EXHIBIT I – GMP AMENDMENT
GMP AMENDMENT TO AGREEMENT BETWEEN OWNER
AND CONSTRUCTION MANAGER AT RISK FOR NORTH COUNTY SERVICE CENTER
AGREEMENT NO. 21-0750-CMAR

CREATIVE CONTRACTORS, INC.
North County Service Center
 Revised 2/9/26
GMP w/addendum #7
PROJECT COST SUMMARY

REQUEST FOR INFORMATION LOG
North County Service Center
Clearwater, FL

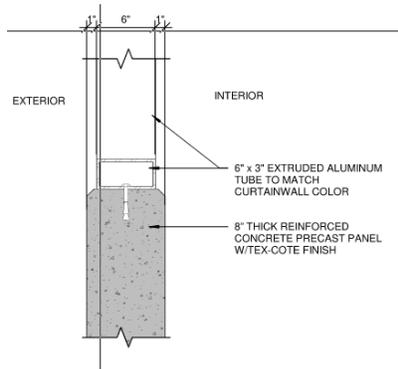
Sheet AG15-3 details the Hendricks aluminum tubes that are to go on the first and second floor of the parking garage. There will be no way to bolt it into the precast panel without putting a hole in to the top of the frame. Please advise if there are any alternative details we can use.

The second-floor aluminum frame details will be revised to show the anchor counter-sunk at surface coming in from outside of the frame, similar to the first-floor perforated panel details. Only the first-floor system is a Hendrick product, the second-floor details show generic aluminum framing by YKK.

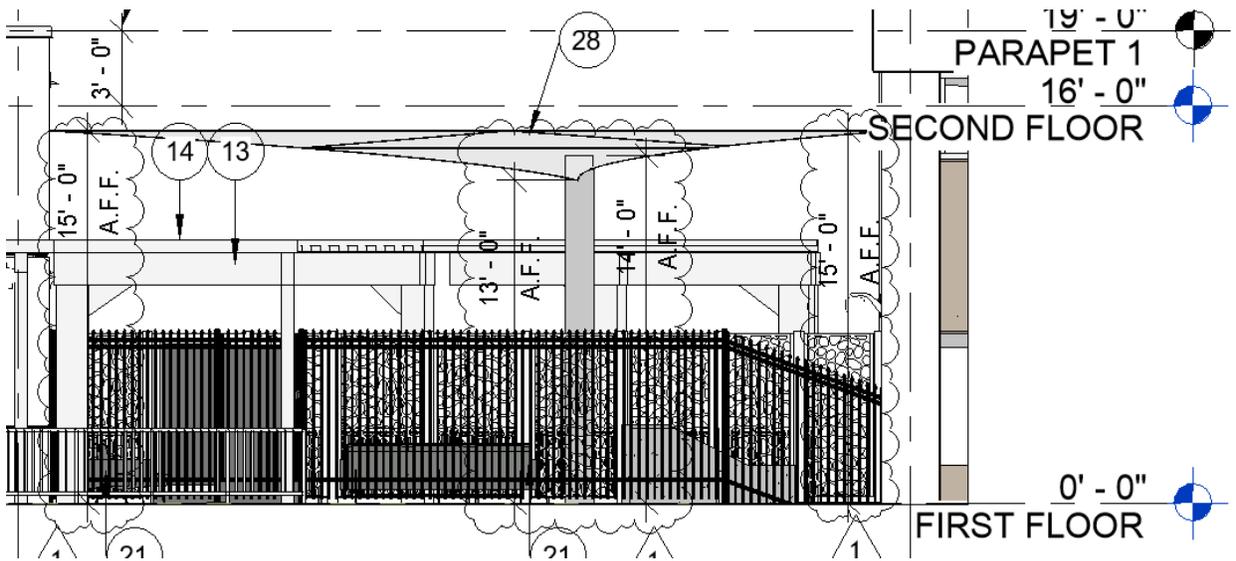
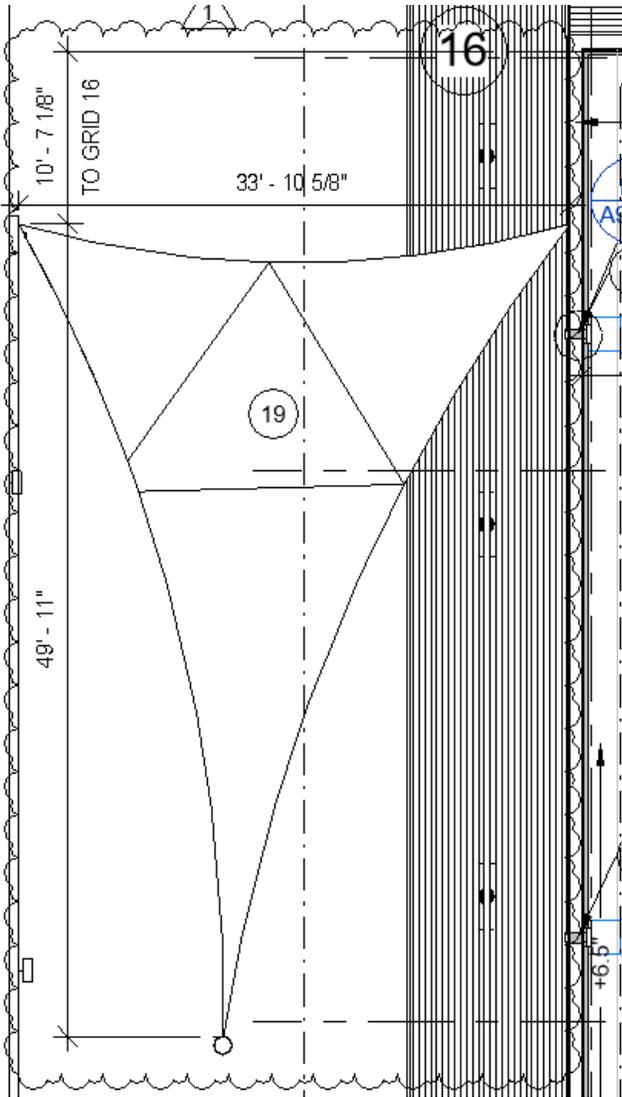
QUESTION:	
Please provide the heights (column height / height at 2 places it is connecting to building / garage) and dimensions of the shade structure	
DATE:	3/17/25

ANSWER:	
<p>The column is at 14'-0" from first floor level, the connect point at the column is 13'-0" A.F.F. and the other two points are at 15'-0" A.F.F. The distance from main building to parking garage is 33'-11" field verify prior to installation. The distance from column to the wall connections are at 49'-11' field verify dimensions prior to installation, see attachment. An Addendum will be issued with these dimensions.</p>	
Alvaro Coronel	
DATE:	3/18/2025
